Spokane Park Board Agenda

Oct. 12, 2017 – 1:30 p.m.

**CITY OF SPOKANE
PARKS AND RECREATION DEPARTMENT
CHANGE ORDER NO. 6**

| SHEET TITLE: PEDESTRIAN RAILING AND CURB DETAILS 2 OF 2 | |

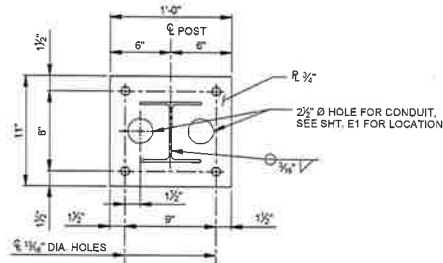
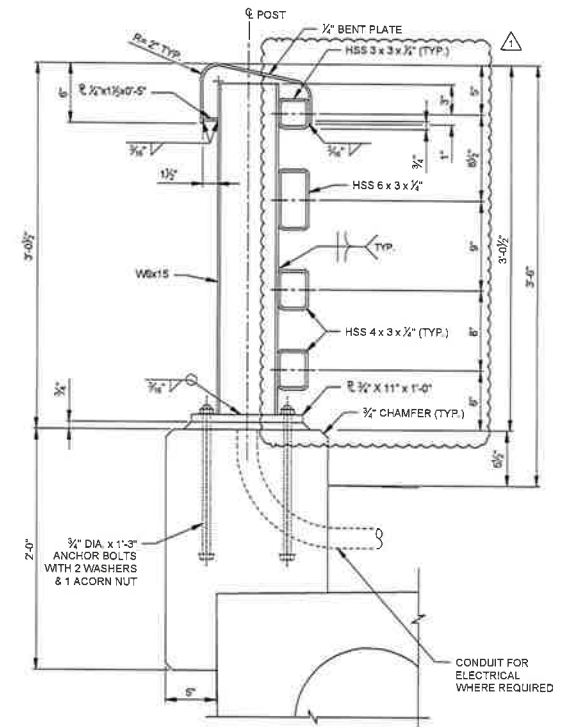
Description: Please provide any additional costs required to make the described modifications to the bridge railing per the attached CH drawing SB-36.

this change covers the railing change from the original bid. 3x3 tubing to 4x3 tubing

ASI 12-1

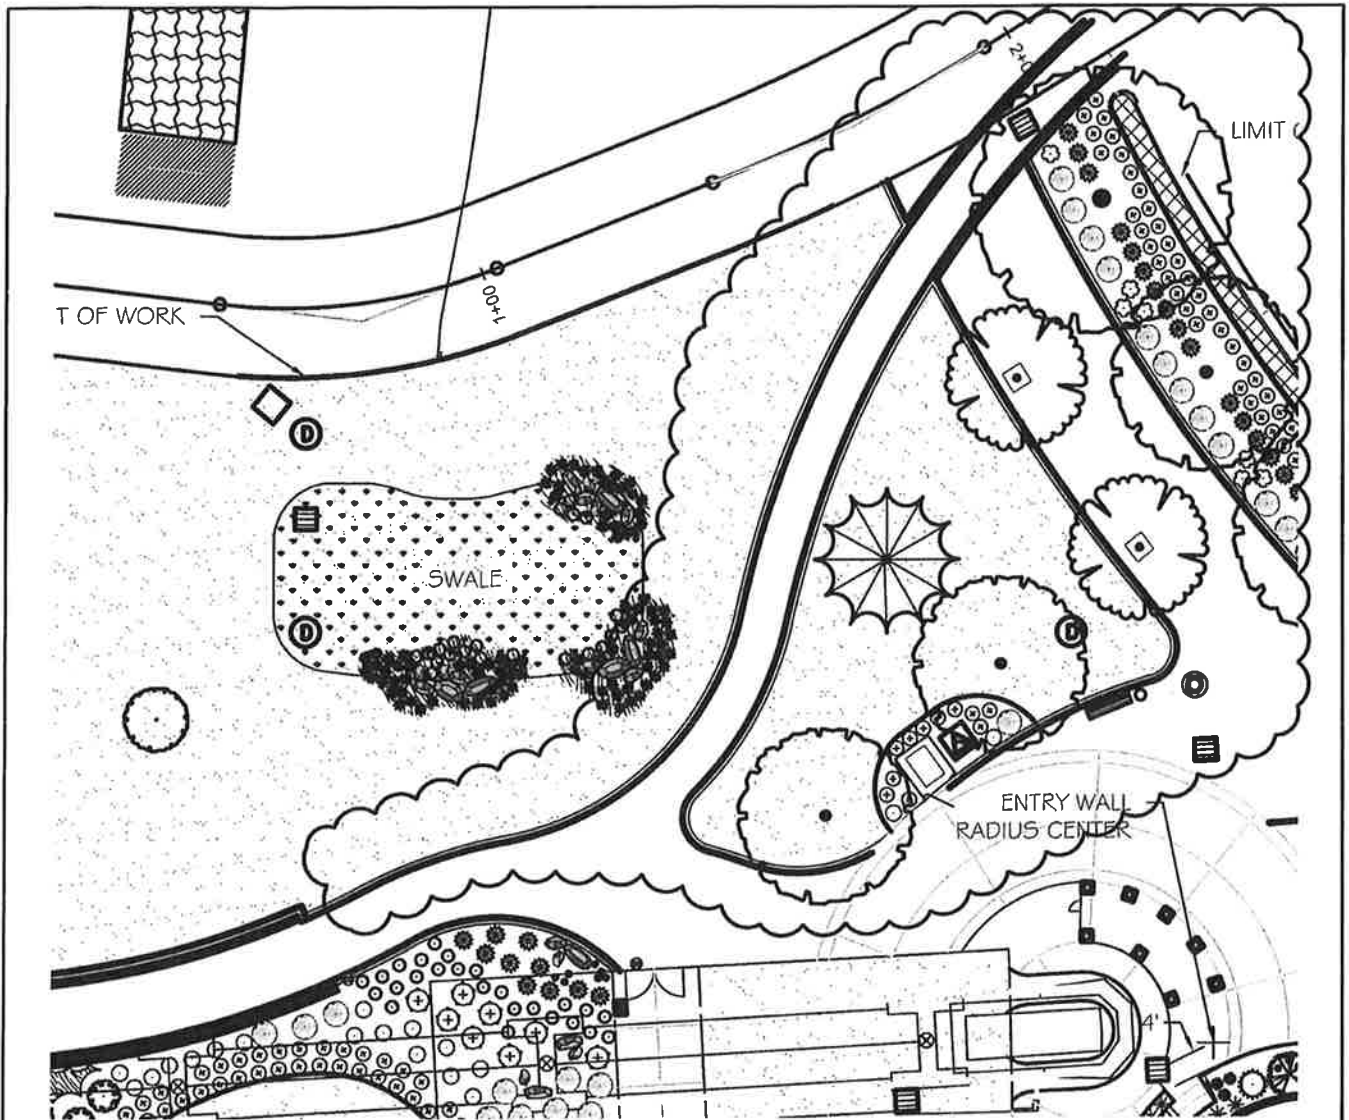
1. INCREASE LENGTH OF NORTH ENTRY WALL FROM 20' TO 119' AND REVISE LAYOUT AS SHOWN.
2. REMOVE BOULDER WALL SOUTH OF POST STREET ENTRY WITH A C.I.P. CONCRETE WALL FINISHED WITH CUT BASALT STONE TO MATCH OTHER SITE WALLS. INCREASE LENGTH OF WALL FROM 50' TO 121' AND REVISE LAYOUT AS SHOWN.
3. INCREASE MOW STRIP LENGTH FROM 50' TO 178' IN RESPONSE TO LENGTHENED ENTRY WALL.
4. REMOVE 5 KELSEY DOGWOOD SHRUBS FROM SOUTH ENTRY SHRUB BED AND REVISE PLANTING LAYOUT AS SHOWN.
5. REFER TO SKETCH 'ASI 12-2' FOR RADIUS CENTER LOCATION.

ASI 12-2

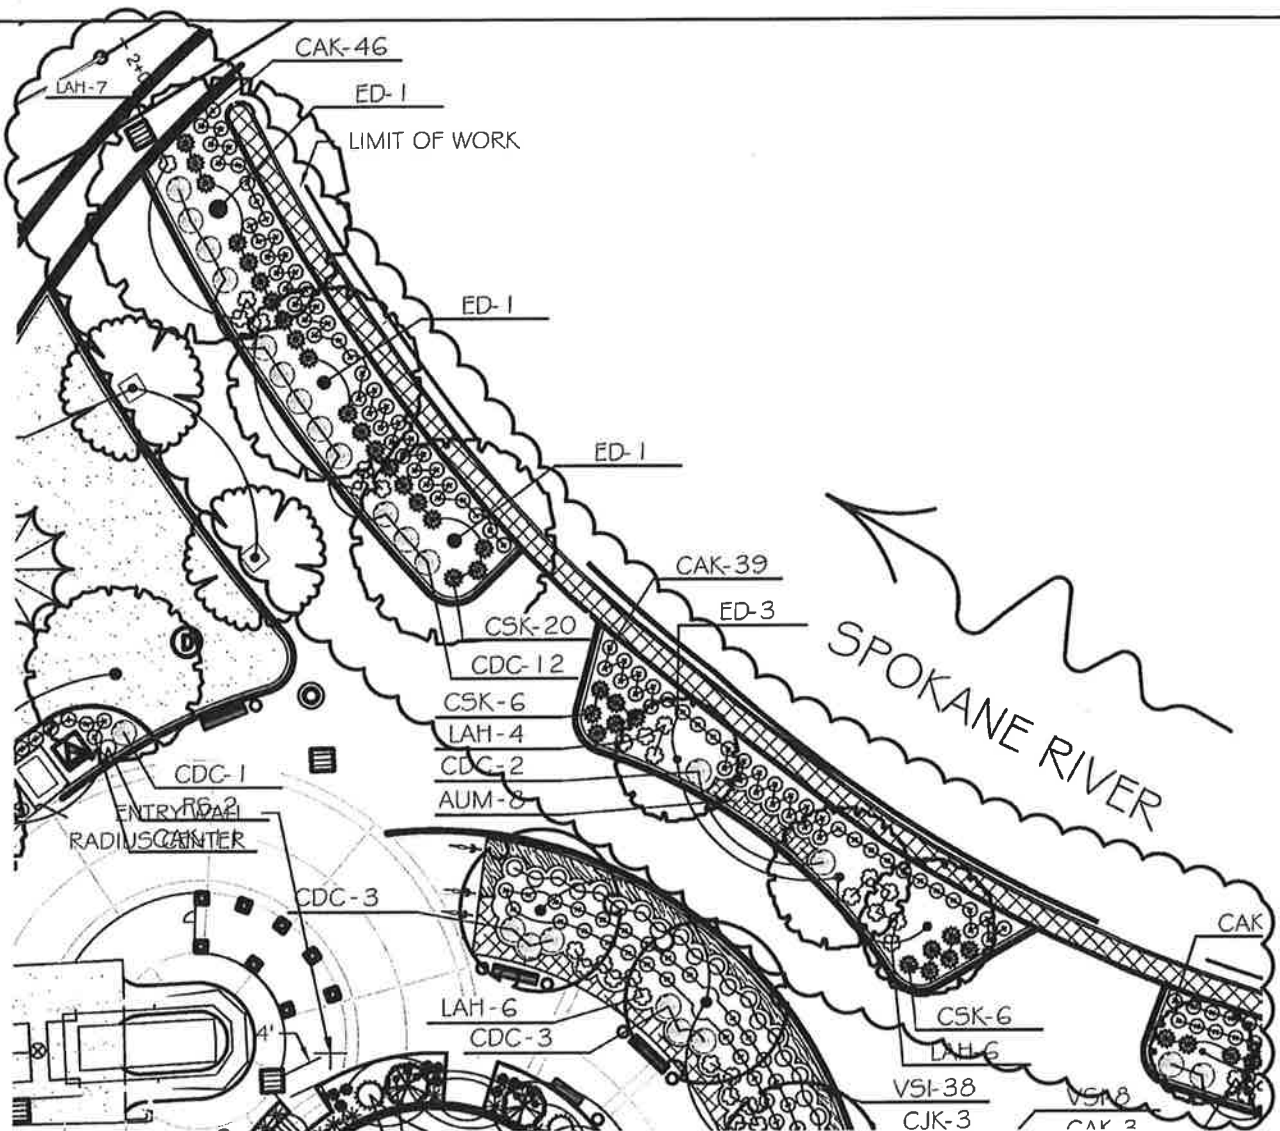
1. PROVIDE ASPHALT PATHWAY, BORDERED BY 12"X12" REINFORCED CONCRETE EDGING, THROUGH NORTHWEST LAWN, AS SHOWN. PATHWAY WIDTH SHALL BE 8' AND PROVIDE 5' RADIUS AT CORNERS, AS SHOWN.
2. LAWN AREA DECREASES BY 1,515 S.F.
3. 12"X12" REINFORCED CONCRETE EDGING INCREASES BY 292 L.F.
4. REFER TO SUBSEQUENT ASI #12 SKETCHES FOR MORE INFORMATION REGARDING PLANTING AT SEAWALL.

ASI 12-3

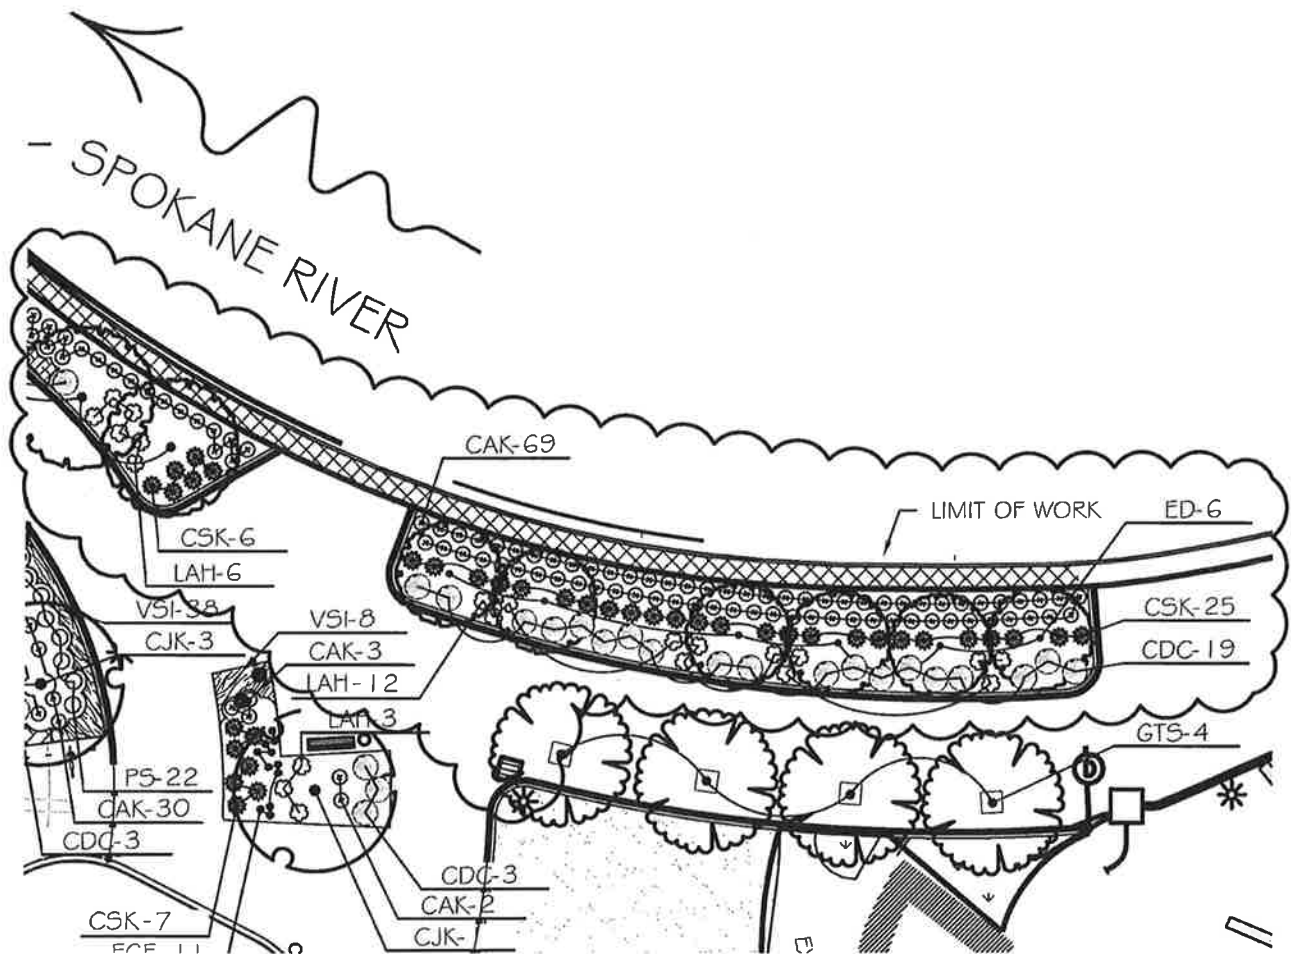
1. REMOVE 12 TREE GRATES AND REPLACE WITH AT-GRADE SHRUB BEDS, AS SHOWN.
2. SHRUB BEDS SHALL BE DEFINED BY 12"x12" REINFORCED CONCRETE EDGES, 383 L.F. PER PROPOSED PLAN.
3. REFER TO PLANT CALLOUTS FOR PROPOSED SPECIES AND QUANTITIES.
4. REFER TO SUBSEQUENT ASI #12 SKETCHES FOR MORE INFORMATION REGARDING PLANTING AT SEAWALL.

ASI 12-4

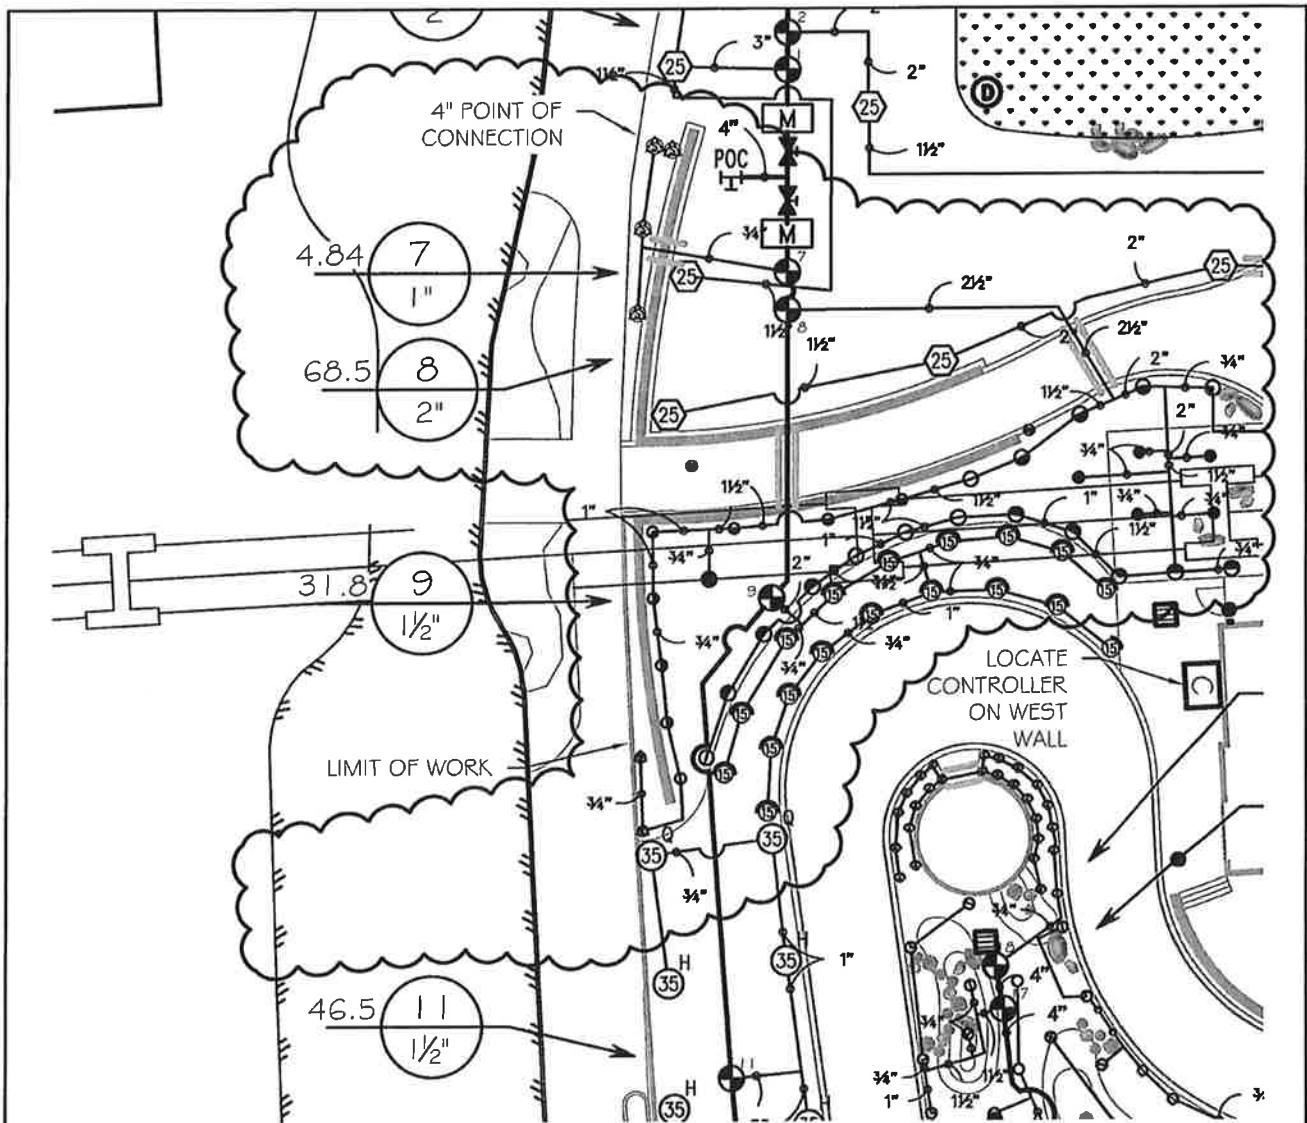
1. REFER TO PRIOR ASI #12 SKETCHES FOR MORE INFORMATION REGARDING PLANTING AT SEAWALL.
2. PROVIDE 5' RADIUS AT LAWN CORNER, AS SHOWN.
3. REFER TO PLANT CALLOUTS FOR PROPOSED SPECIES AND QUANTITIES.

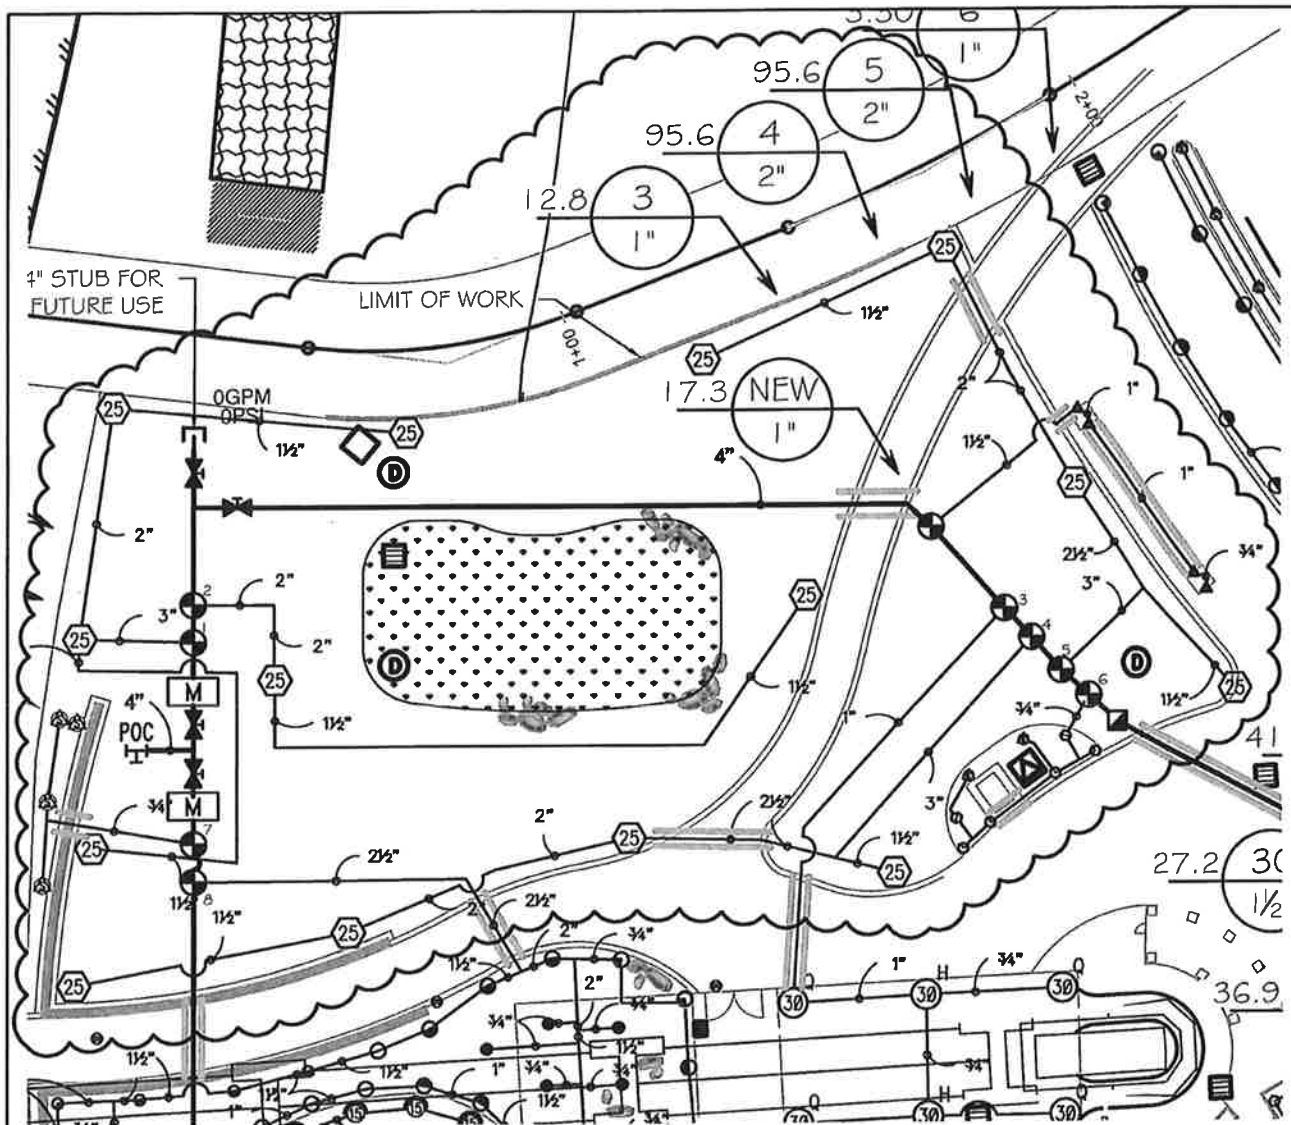
1. REMOVE ZONE #10 IN ITS ENTIRETY.
2. REVISE ZONE #8 BY SHIFTING HEADS AROUND NEW ENTRY WALL DESIGN. ADD ONE 15' FULL SPRAY AND STRIP STRAYS TO THE WEST OF THE ENTRY WALL, AS SHOWN. ZONE #8 INCREASES TO 68.5 GPM.
3. REVISE ZONE #7 TO INCLUDE SIDE STRIP SPRAYS WEST OF THE REVISED ENTRY WALL. PROVIDE SLEEVING THROUGH WALL TO REACH SPRAY ZONE AREA. ZONE #7 INCREASES TO 4.84 GMP.

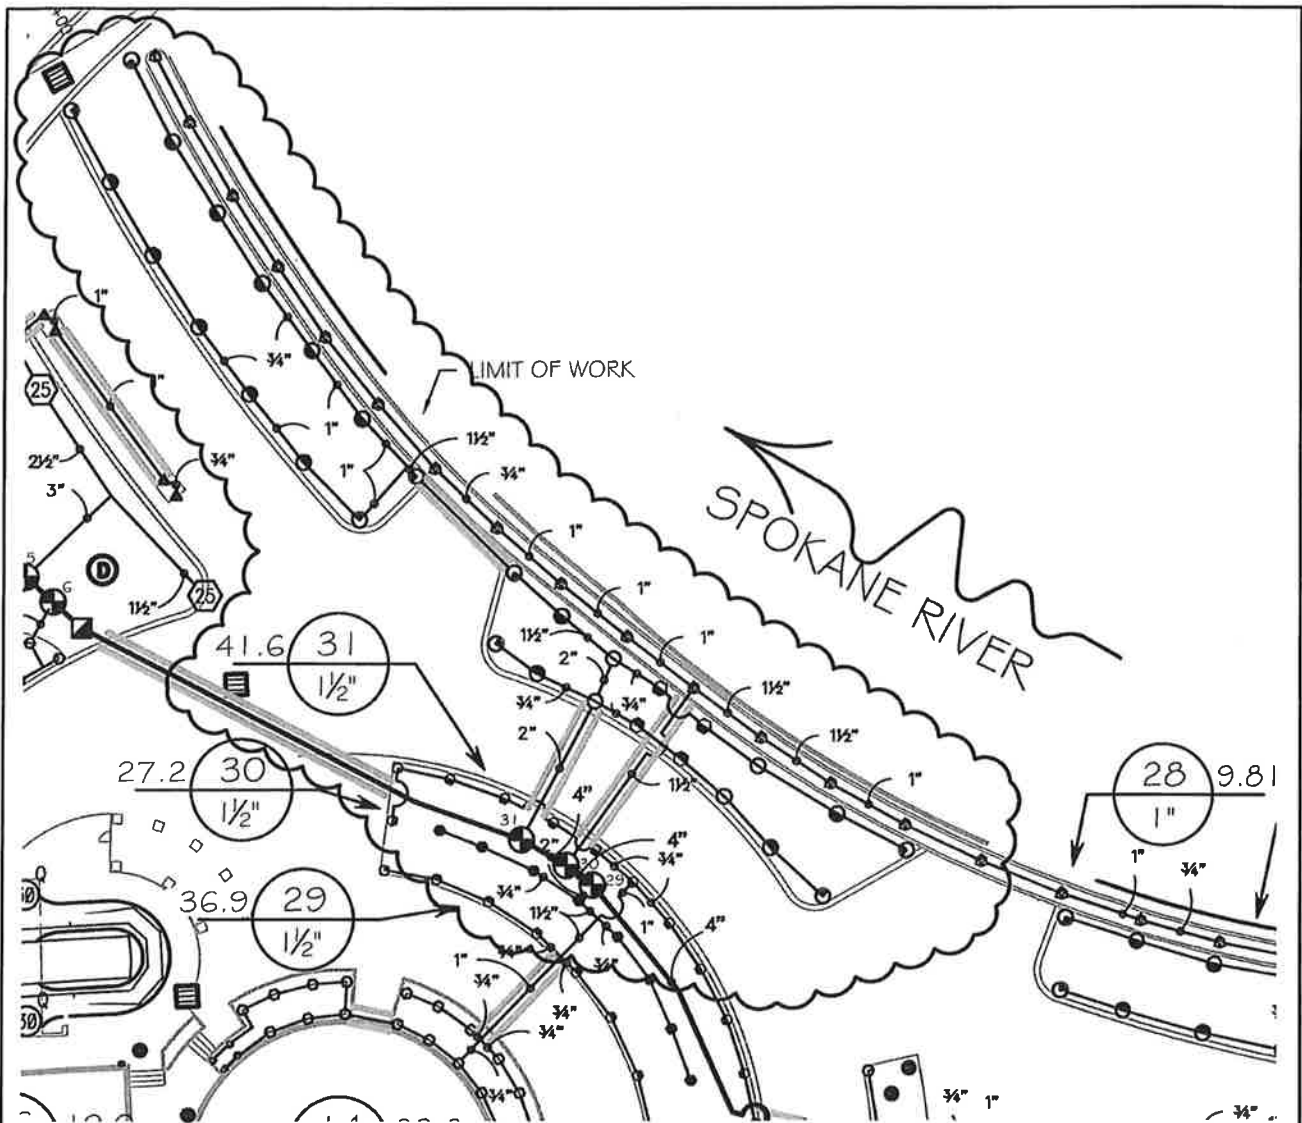
1. SHIFT 25' ROTOR OF ZONE #1 IN RESPONSE TO NEW PATHWAY, AS SHOWN. IRRIGATION WILL SPRAY OVER PATH.
2. ADJUST ROTORS TO RESPOND TO NEW ENTRY WALL DESIGN, ADD SLEEVING UNDER NEW PATHWAY (ZONES #4 AND #5), AS SHOWN.
3. ADD NEW ZONE TO IRRIGATION LOCUST TREES ON THE SOUTHERN EDGE OF LOCUST LANE, AS SHOWN.

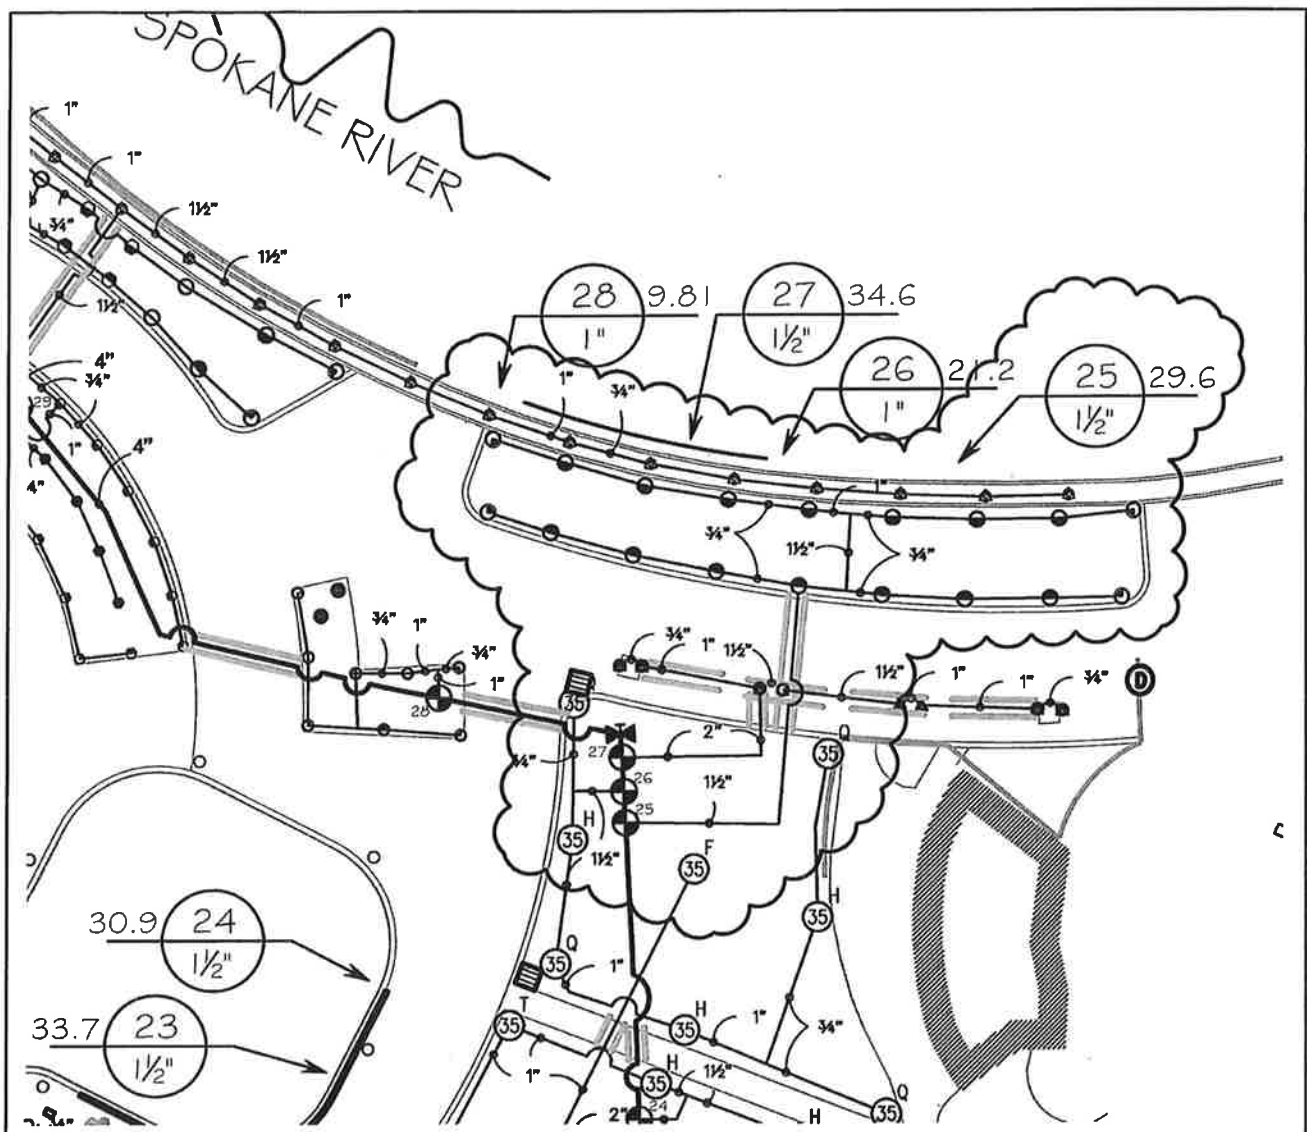
1. ZONE #31 - REPLACE BUBBLERS WITH SHRUB SPRAYS, AS SHOWN. REMOVE SLEEVING BETWEEN PRIOR-DESIGNED TREE GRATES BUT PROVIDE BETWEEN PROPOSED SHRUB BEDS, AS SHOWN. ZONE #31 REDUCES TO 41.6 GPM. REPLACE 2" VALVE WITH 1.5" VALVE.
